SAN FRANCISCO PLANNING DEPARTMENT

Discretionary Review Abbreviated Analysis HEARING DATE: OCTOBER 7, 2010

Date: September 29, 2010
Case No.: **2009.1003D**
Project Address: **1138-1140 Page Street**
Zoning: RM-2 [Residential, Mixed, Moderate Density]
40-X Height and Bulk District
Block/Lot: 1219/011
Project Sponsor: Toby Morris
Kerman Morris Architects
69A Water Street
San Francisco, CA 94133
Staff Contact: Aaron Starr – (415) 588-6362
aaron.starr@sfgov.org
Recommendation: **Do not take DR and approve as modified**

1158 Page Street, Northern Light Well
(Picture 1)

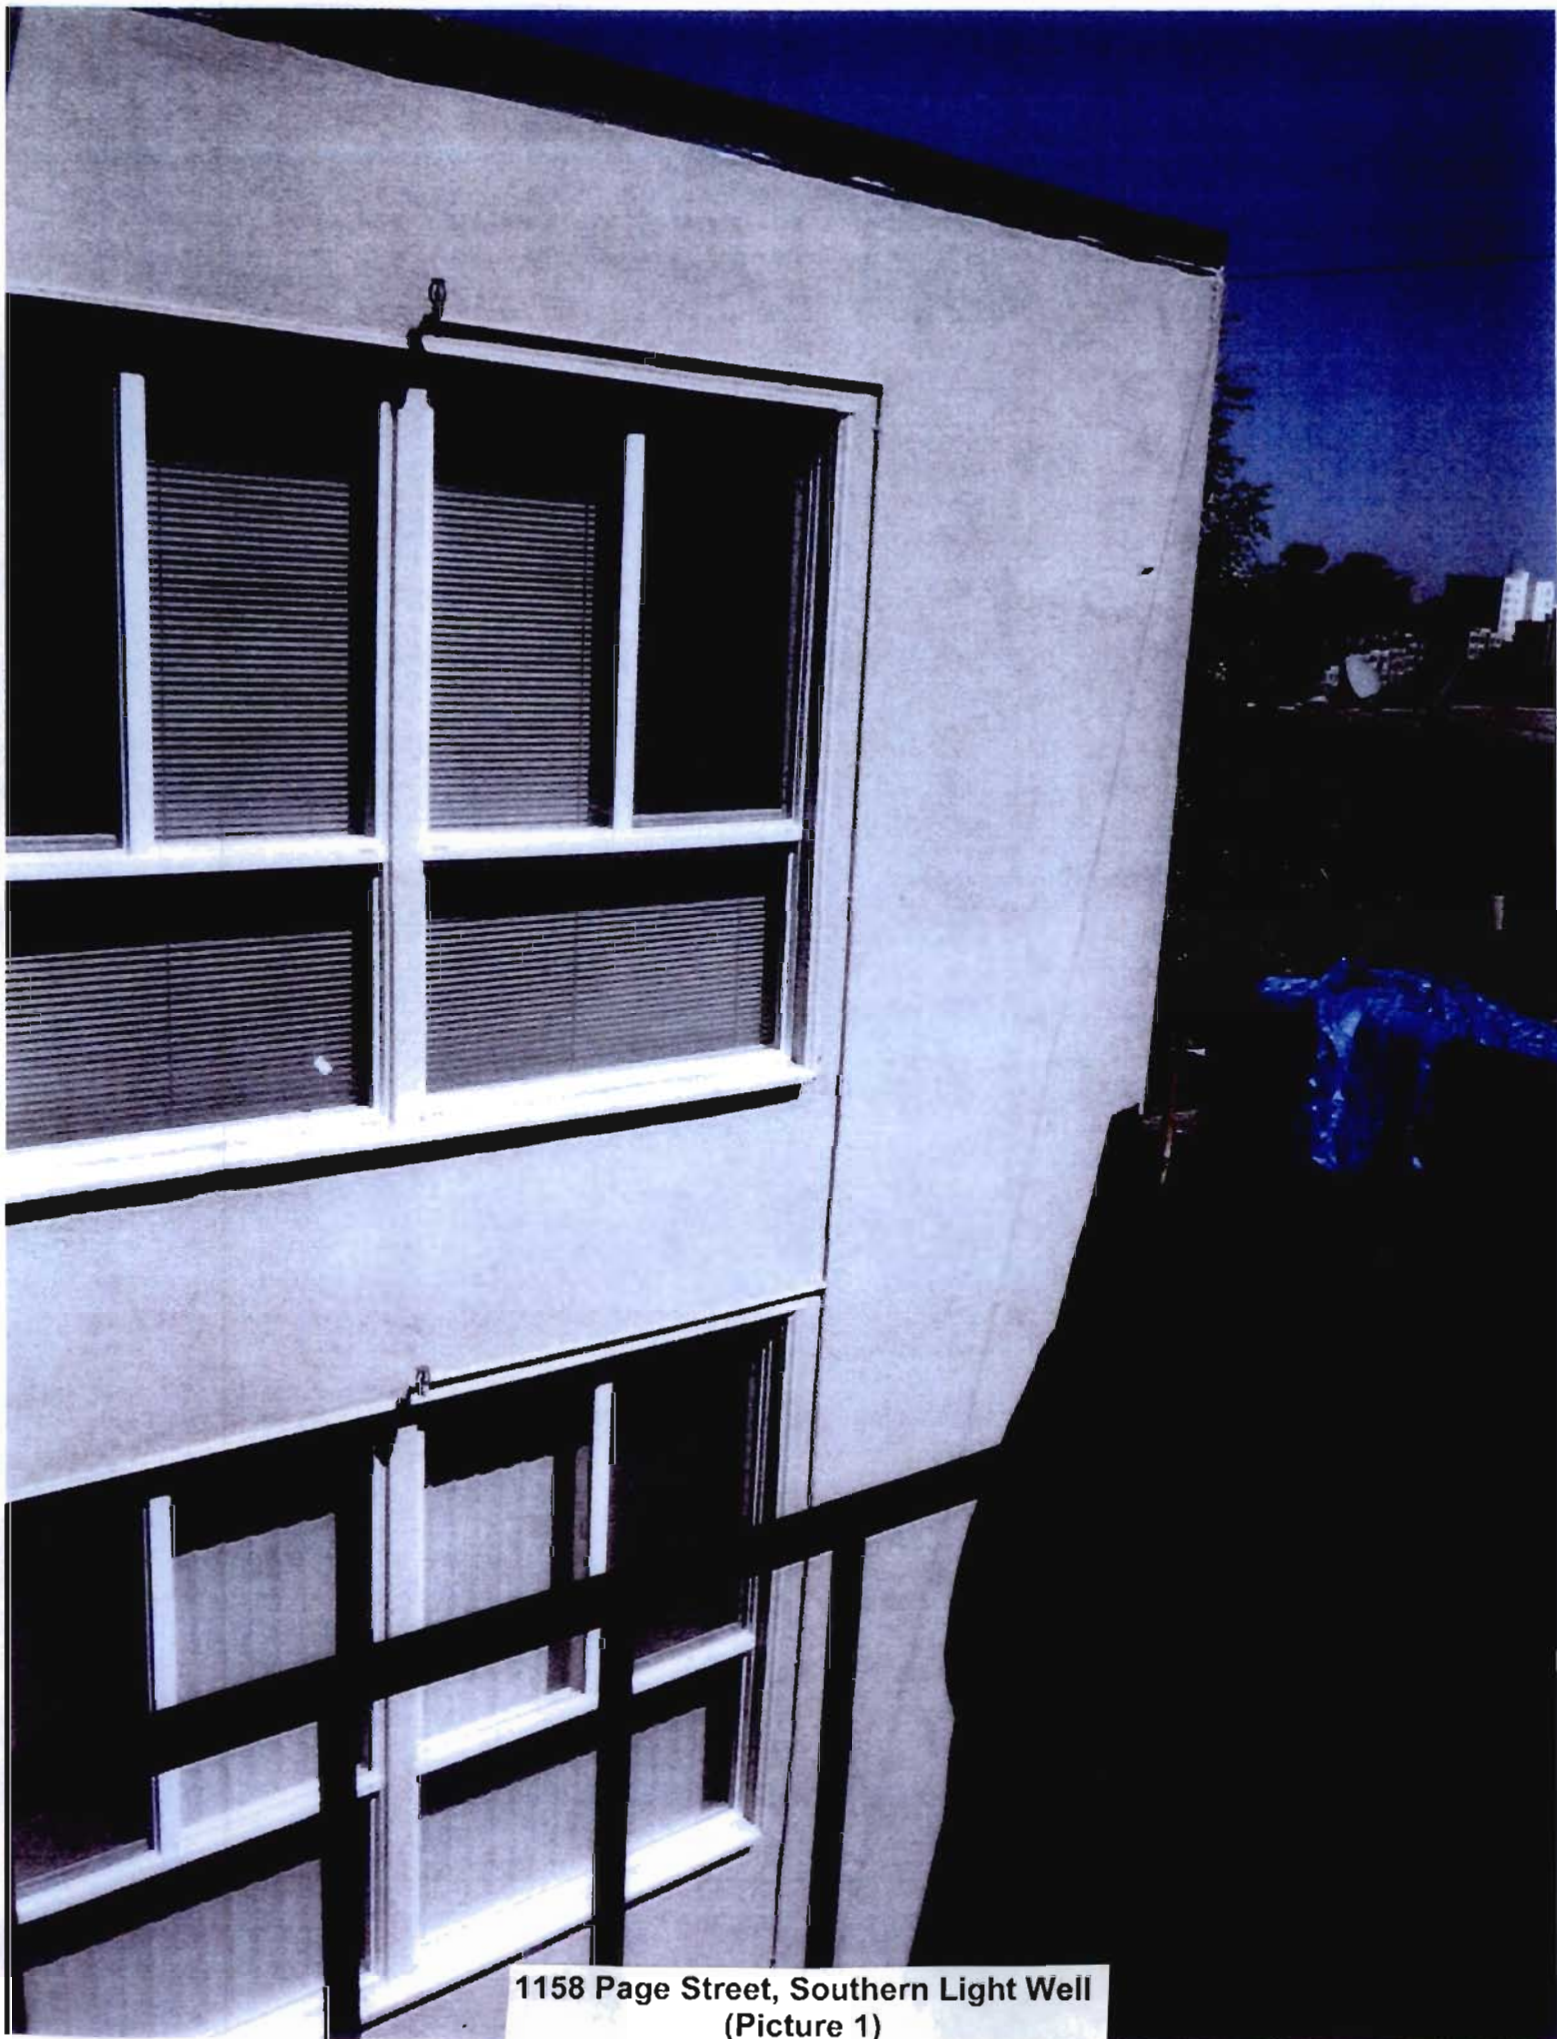
Ms. Kazeminezhad owns the multi-unit residential property located at 1158 Page Street, directly to the west of the Project, the residents of which depend on two light wells adjacent to the western property line of the Project for light and air. We have attached for your reference the following photographs and plans, which show the current conditions at 1158 Page Street: 1) an aerial photograph of 1158 Page Street, which shows its configuration and position with respect to the Project site; 2) a first floor plan for 1158 Page Street; and 3) several photographs of the northern and southern light wells that were taken from various perspectives. As you will see, the northern and southern light wells are the *only* source of natural ventilation and sunlight to several bedrooms and living rooms at 1158 Page Street – in fact, for one unit on each floor, *every single window* faces onto one of the two light wells.

DRAWING
A-3.3

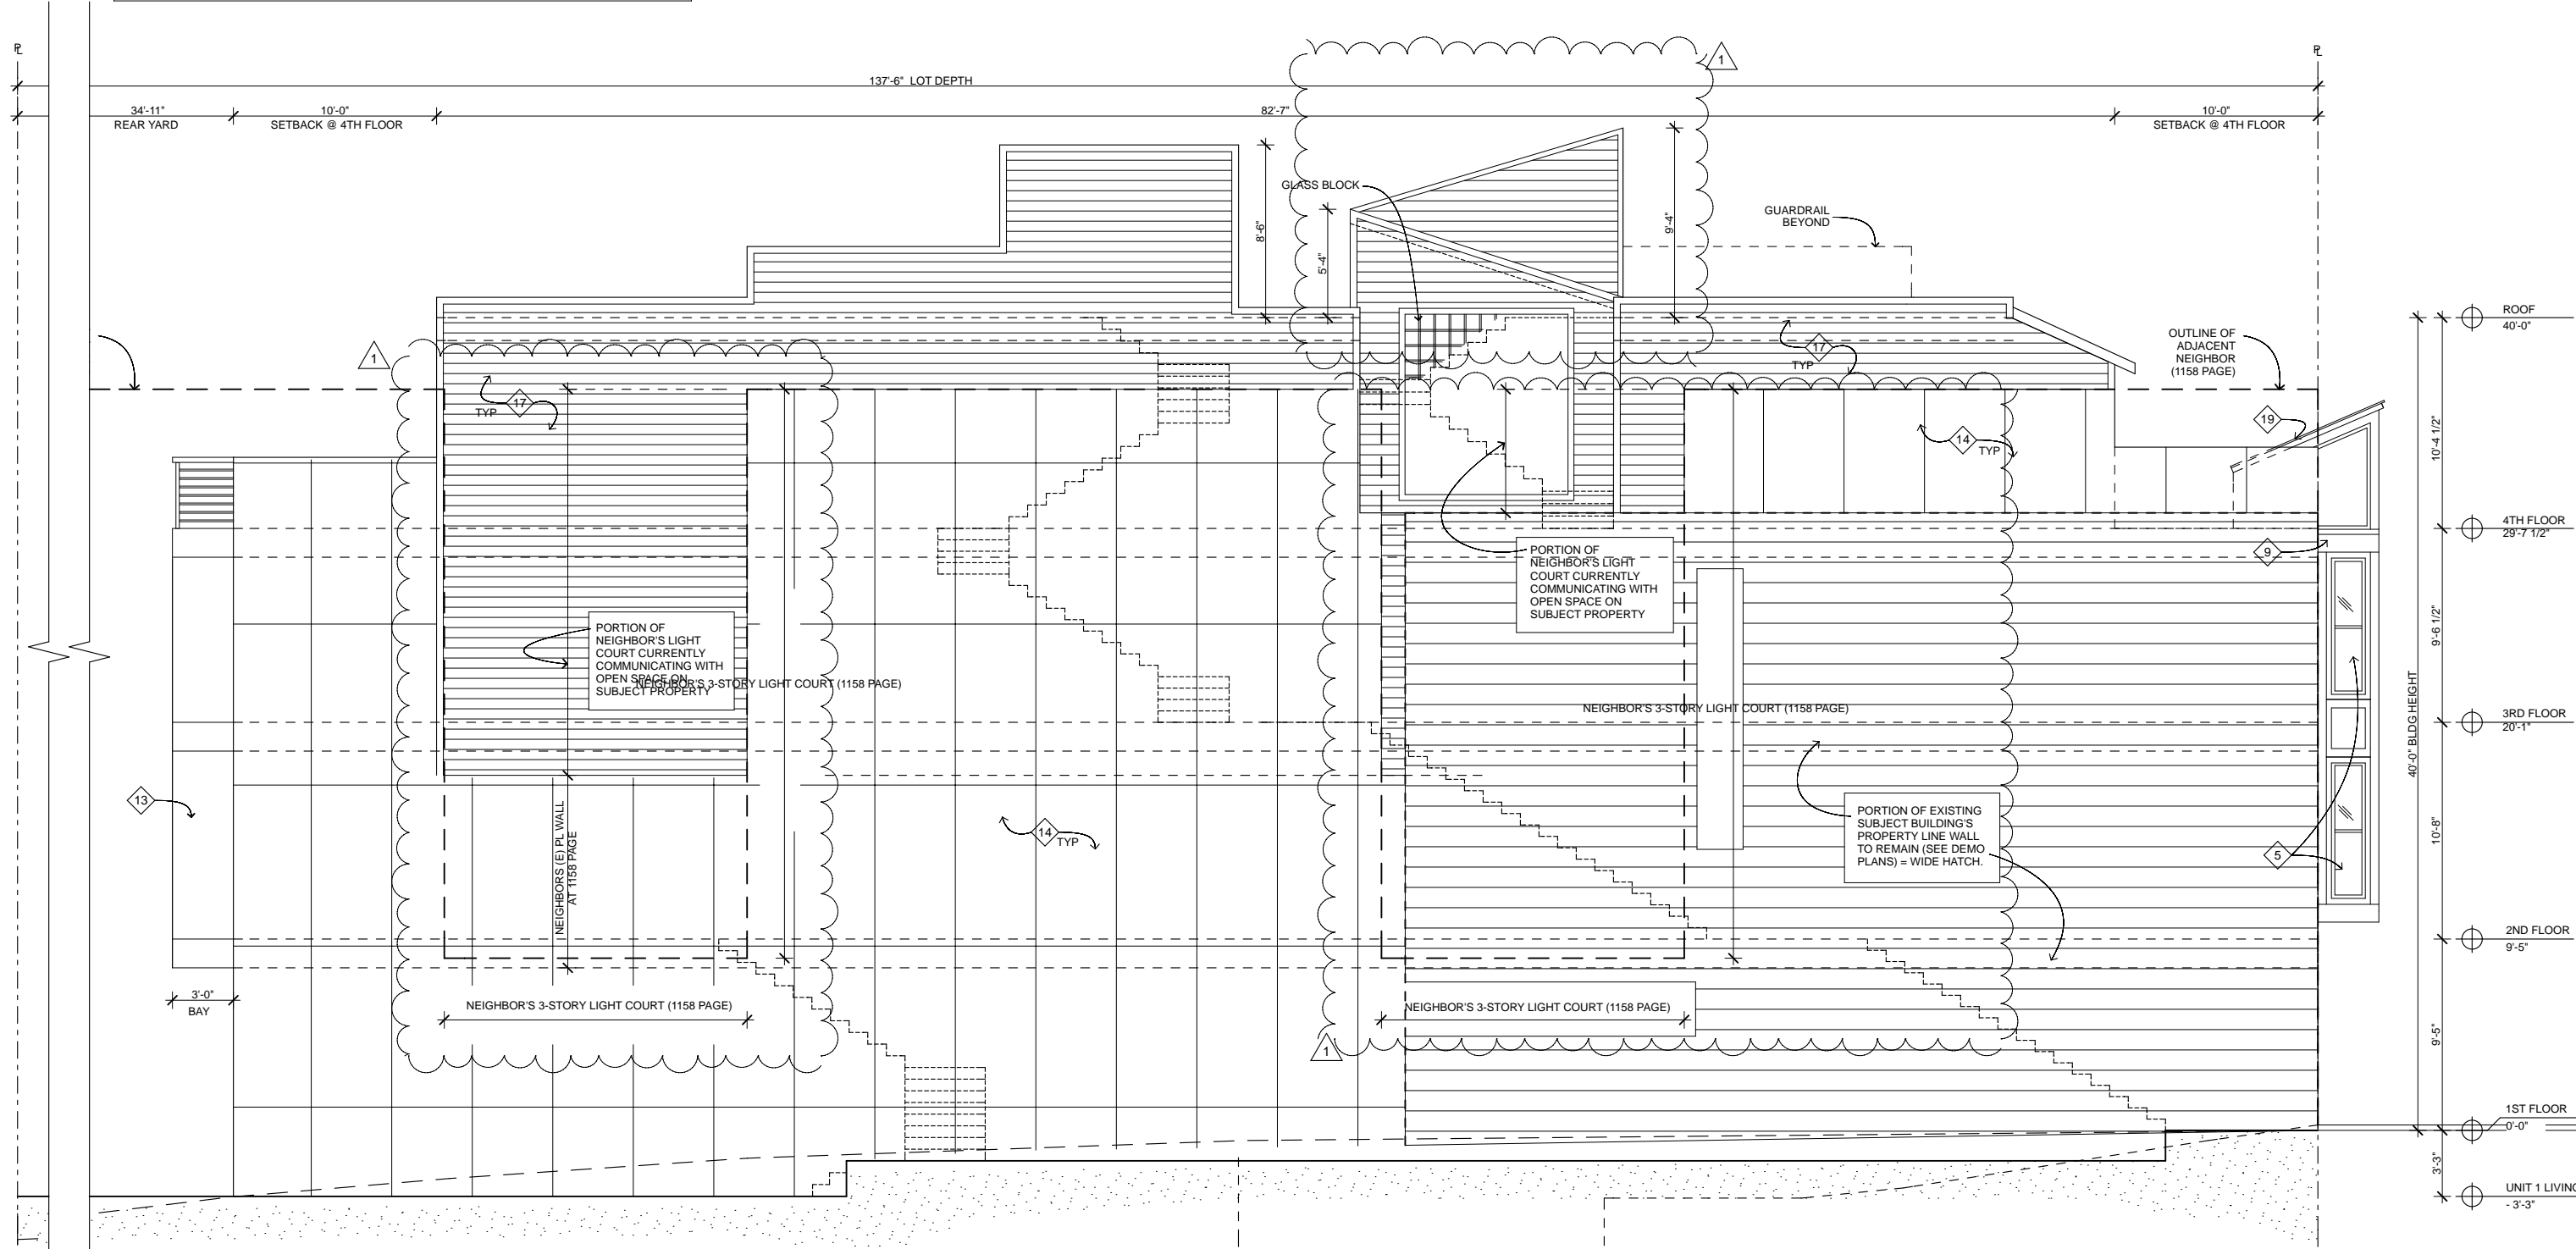
Also important to note is that the West elevation portrayed on sheet A-3.3 of the Kerman/Morris plans dated 5/28/10 seems to imply that our building's light-wells only serve its third and fourth floors. This is not the case. We currently have a driveway on the ground floor and above that have three stories of living spaces all of which access and use the light wells. The elevation drawing in question should therefore show their wall siding starting at the second floor line and not closer to the third.
